CITY OF DARIEN

PLANNING AND ZONING COMMISSION

Elizabeth Ide Elementary School - Site Review Responses

Review of Traffic and Park Study

PARENT DROP-DFF STACKING EXHIBIT

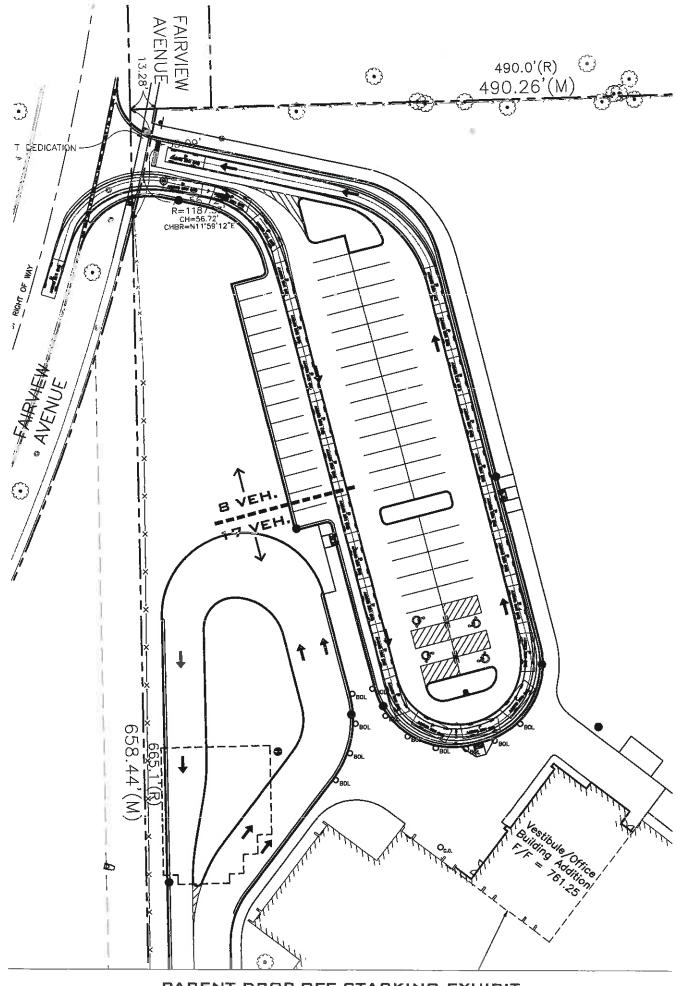
While the proposed modifications will increase the amount of student drop-off/pick-up stacking, the traffic study does not address whether the additional stacking will be sufficient to meet the school's peak demand, particularly during the afternoon pick-up period when parents arrive early and wait for their children. The applicant should evaluate the drop-off/pick-up operations to determine if the proposed stacking is sufficient to meet the peak demand, and, if not, the impact on the internal circulation and external roadways. Response: The attached exhibit shows the queuing along the student loading zone with room for 17 vehicles to be loaded simultaneously during afternoon dismissal. There is room for 8 or 9 additional vehicles to queue without spilling back onto Fairview Avenue while waiting to get to the curb. During the existing afternoon dismissal, there were 15 vehicles in the lot at peak times.

SCHOOL BUS STACKING EXHIBIT

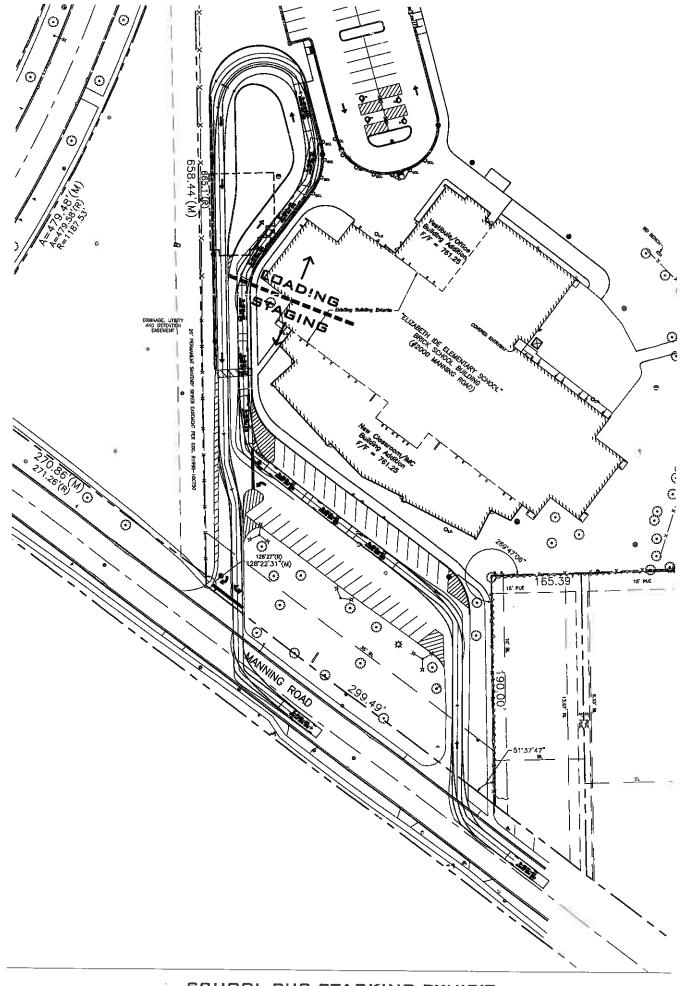
- How many buses are used to serve the school?
- How many buses can be accommodated along the bus loading lane and is it sufficient to meet the peak demand? The applicant should provide an exhibit showing the number of buses that the loading lane can accommodate.
- Are the radii through the school site and at the access drives sufficient to accommodate the bus traffic, particularly considering the bus stacking that will be occurring along the bus loading lane? The applicant should include an exhibit showing the bus maneuvers entering from Manning Road, traversing the school site, and exiting to Manning Road.

- Based on the bus maneuvering exhibit included in the Erickson Engineering memorandum, it appears that a bus will not be able to by-pass a bus that is waiting along the north portion of the loading zone. The School District should clarify if the bus loading zone was designed with a by-pass lane.
- The bus maneuvering exhibit included in the Erickson Engineering memorandum did not show how a bus will complete a right-turn movement from the school onto Manning Road. It appears that the bus will either have to encroach on the left-turn lane along the access drive and/or the eastbound lane of Manning Road to complete the right-turn movement. The School District should clarify how buses will complete the right-turn movement.

- How many buses are used to serve the school? Response: Ten school buses.
- How many buses can be accommodated along the bus loading lane and is it sufficient to meet the peak demand? The applicant should provide an exhibit showing the number of buses that the loading lane can accommodate. Response: Ten school buses. Please note that in the afternoon only four buses will load at a time while the other buses are queued off-street in the south parking lot. See attached Exhibit.
- Are the radii through the school site and at the access drives sufficient to accommodate the bus traffic, particularly considering the bus stacking that will be occurring along the bus loading lane? The applicant should include an exhibit showing the bus maneuvers entering from Manning Road, traversing the school site, and exiting to Manning Road. Response: See attached Exhibit.
